Our Ref: MA08365-1

Date: 1 September 2010

RE: PREFERRED PROJECT REPORT – WALLACE WURTH BUILDING (MP 09_075)

Revised Section – Planter on High Street

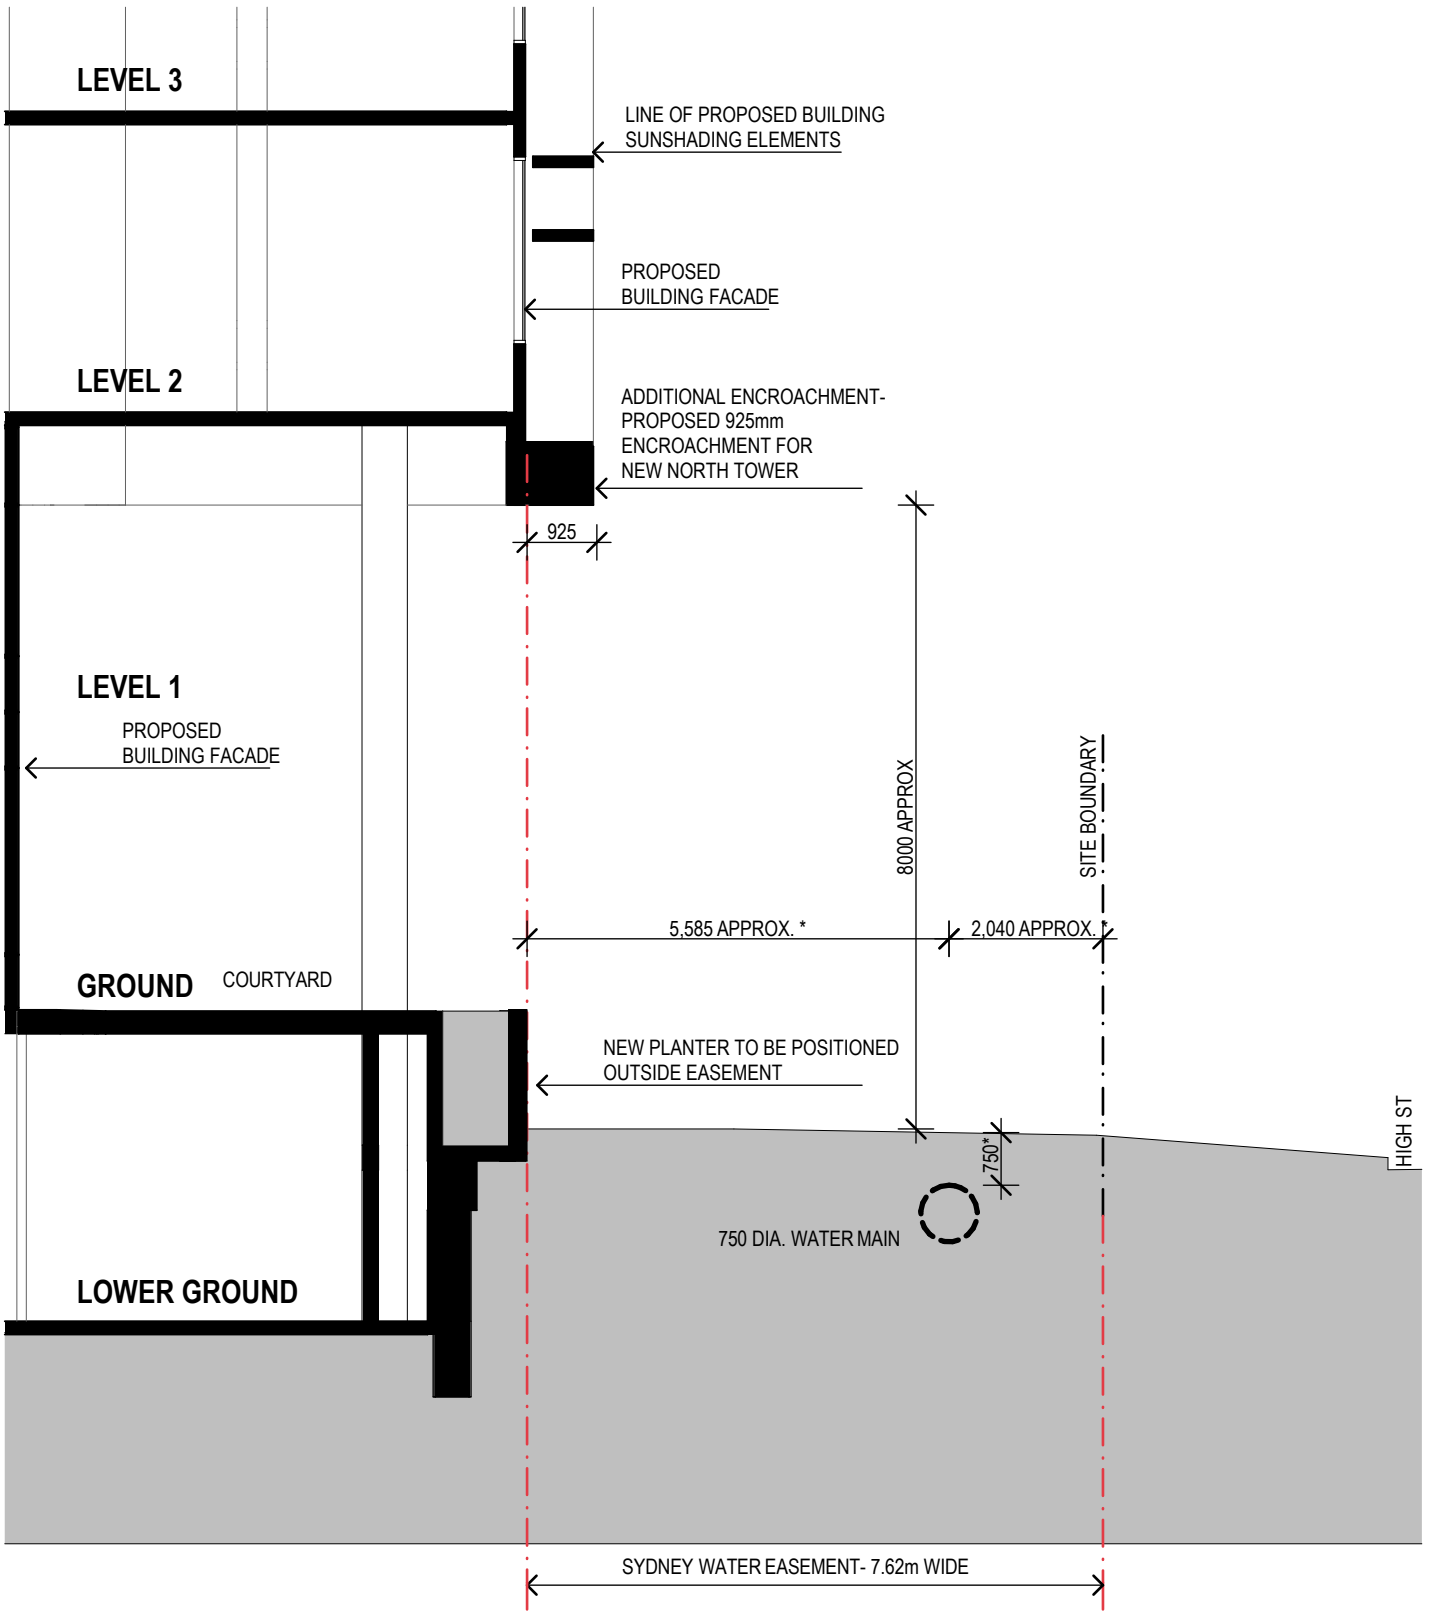
- The planter structure along High Street presented a significant structure within the easement zone and was unlikely to be supported. The plans have since been amended to move the planter structure out of the easement, as per the attached section (**Attachment 1**). These have been provided to Sydney Water for comment. A condition of consent requiring Sydney Water approval of final designs is considered an appropriate mechanism to deal with any further issues in relation to the proposed encroachment. This has been communicated to Sydney Water and it is requested that Council seek to liaise with them in formalising this arrangement.
